# Access Compliance Report

## Public Rights-of-Way

### (Curb Ramps)

Intersection ID: 44479	Main Street: REDDING_GLEN_AV	Cross Street: DARWICK_ST	Location: SW
ADA ID: 587EEAC9E216	Ramp Type: PerpDiag	Initial Pass/Fail: Fail	Overall Compliance: No
Severity Score: 13.75			
Codes/Mitigation Info/Possible Solution		Field Measurements/Component Compliance

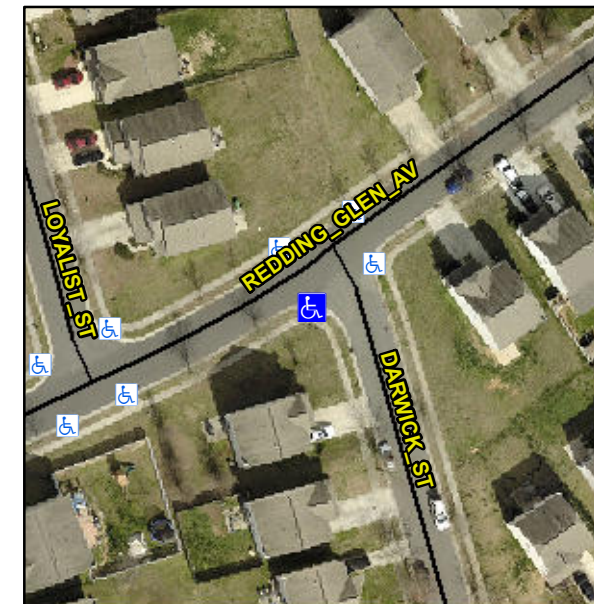
**Not Found, R304.2.2, R304.5.3**

Compliance	Description	Data	Compliance	Description	Data
N/A	Ramp Length (in)	44.5	No	Ramp Slope (%)	8.6
Yes	Ramp Width (in)	49.0	No	Ramp XSlope (%)	2.8
N/A	Flare Type LT	N/A	N/A	Flare Type RT	N/A
N/A	Flare Slope LT (%)	N/A	N/A	Flare Slope RT (%)	N/A
N/A	Flare Traversable LT?	N/A	N/A	Flare Traversable RT?	N/A
N/A	Landing Length (in)	N/A	N/A	DWS Provided?	N/A
N/A	Landing Width (in)	N/A	N/A	DWS Contrast?	N/A
N/A	Landing Slope (%)	N/A	N/A	DWS Length (in)	N/A
N/A	Landing X Slope (%)	N/A	N/A	DWS Full Width?	N/A
N/A	Landing Curb? (Y/N)	N/A	N/A	DWS Offset (in)	N/A
N/A	Shared Landing?	N/A			
N/A	Gutter Ponding?	N/A	N/A	Gutter Slope (%)	N/A
N/A	Gutter Lip Ht (in)	N/A	N/A	Gutter X Slope (%)	N/A
N/A	Painted X Walk1?	No	N/A	Painted X Walk2?	No
	X Walk 1 Direction	To E		X Walk 2 Direction	To N
N/A	X Walk 1 Width (in)	N/A	N/A	X Walk 2 Width (in)	N/A
	X Walk 1 Slope (%)	1.1		X Walk 2 Slope (%)	4.6
	X Walk 1 X Slope (%)	0.9		X Walk 2 X Slope (%)	0.8

**Remove & Replace Curb Ramp With Two New Directional Ramps or Equivalent.**
